Access Compliance Report Public Rights-of-Way (Curb Ramps)

Main Street: LEMON_HEIGHTS_DR Cross Street: SKYLINE_DR Location: S

ADA ID: RPRK211014105922 Ramp Type: Type 7 - Directional 2 Initial Pass/Fail: Fail Overall Compliance: No Severity Score: 2

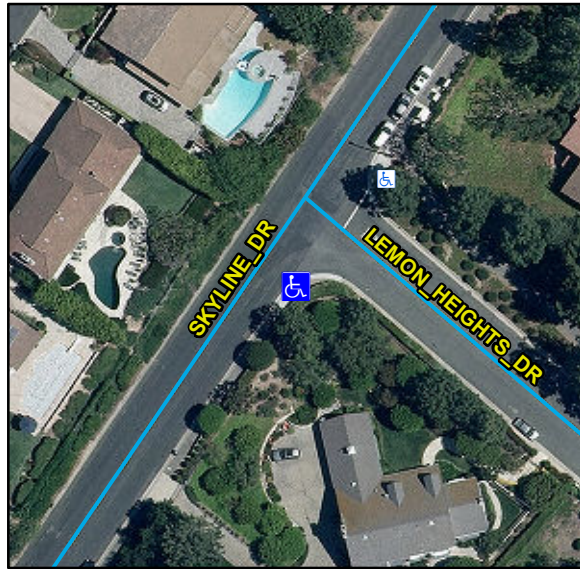
Compliance	Description	Data	Compliance	Description	Data
N/A	Ramp Length (in)	224	N/A	Flare Type LT	
Yes	Ramp Width (in)	60			N/A
Yes	Ramp Run Slope (%)	4.7	N/A	Flare Slope LT (%)	N/A
No	Ramp Cross Slope (%)	2.8	N/A	Flare Traversable LT	N/A
N/A	Grade Break	Yes	N/A	Flare Type RT	
N/A	Grade Break Slope (%)	2.6			N/A
N/A	Grade Break Cross Slope (%)	2.1	N/A	Flare Slope RT (%)	N/A
	Addl Para Ramp Left?	No	N/A	Flare Traversable RT	N/A
	Addl Para Ramp Right?	No	N/A	DWS Provided	N/A
N/A	Landing Present	N/A	N/A	DWS Contrast	N/A
N/A	Landing Length (in)	N/A	N/A	DWS Length (in)	N/A
N/A	Landing Width (in)	N/A	N/A	DWS Full Width	N/A
N/A	Landing Run Slope (%)	N/A		DWS Offset Type	N/A
N/A	Landing Cross Slope (%)	N/A	N/A	DWS Left Offset (in)	N/A
N/A	Landing Movement Obstructed?	N/A	N/A	DWS Right Offset (in)	N/A
	Landing Movement Type	N/A			
N/A	Landing Shared	N/A			
N/A	Marked Crosswalk 1	No	N/A	Clear Space	N/A
	Crossing 1 Direction	N	N/A	Clear Space To Crosswalk (in)	N/A

Marked Crosswalk 1 Width (in)	N/A			
N/A	Ramp Inside Crosswalk 1	N/A			
	Crossing 1 Slope (%)	1.7			
	Crossing 1 Cross Slope (%)	4			
N/A	Gutter Ponding	N/A	N/A	Curb Slope	1.3
Yes	Gutter Lip Height (in)	0		Road Run Slope (%)	N/A
N/A	Gutter Run Slope (%)	N/A		Road Cross Slope (%)	N/A
N/A	Gutter Cross Slope (%)	N/A		Parallel Ramp Side	Left
Yes	Overall Surface Condition	Acceptable	Yes	Perp Joint Present	Yes
	Cross Gutter Present?	No		Spandrel Present?	No
	Replace Cross Gutter?	N/A		Replace Spandrel?	N/A

Possible Solutions:

Remove & Replace Entire Ramp.

R304.5.3, STD 1115
